Request for Additional Information No.579, Supplement 1

U.S. EPR Standard Design Certification

Docket No. 52-020

Question 19-366:

Figure 7.3-2—SIS Actuation

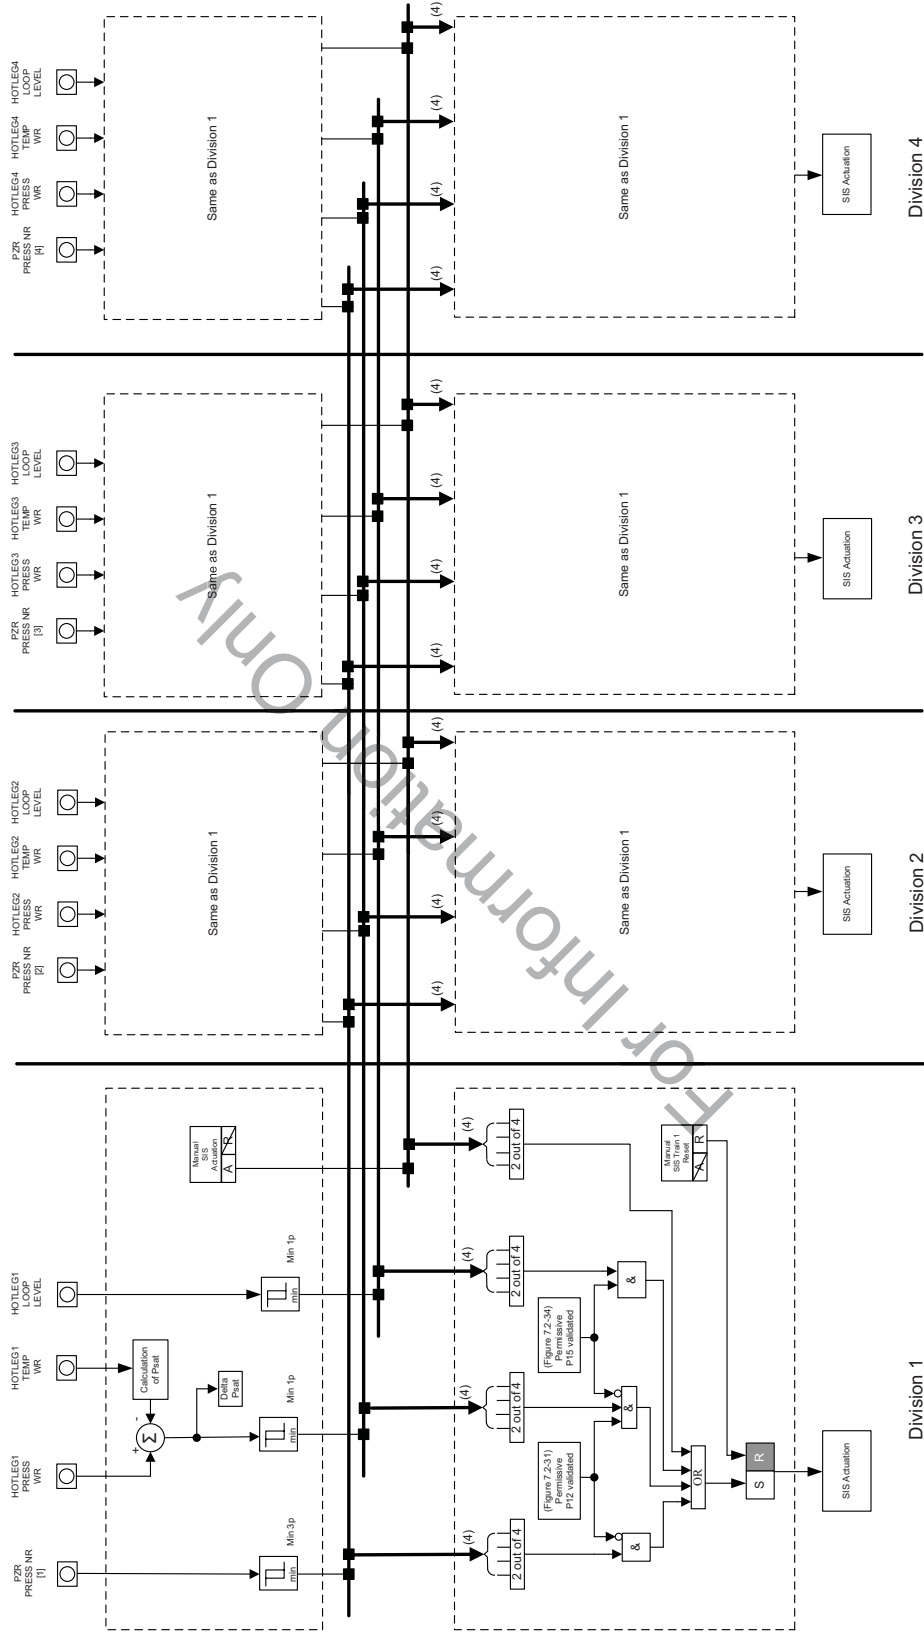
The original purpose of the SIS bypass switch was to disable the automatic safety injection to provide personnel protection for some RCS maintenance related activities during shutdown conditions. A subsequent evaluation of the use of the SIS bypass switch has led to the conclusion that the SIS bypass switch cannot be used for this intended function, and for that reason will be eliminated from the U.S. EPR design.

- U.S. EPR Tier 2 Figure 7.3-2 is revised to remove the bypass switch.
- U.S. EPR FSAR Tier 2 Section 7.3.2.1 is revised to remove discussion of the bypass switch.
- Technical Specification 3.3-2 and bases is modified to remove the bypass switch

(RCP) shut down. It is bypassed above the P15 thresholds. ~~A manual bypass of SIS actuation on low hot leg loop level is provided for protection of personnel working in the RCS components during outages.~~
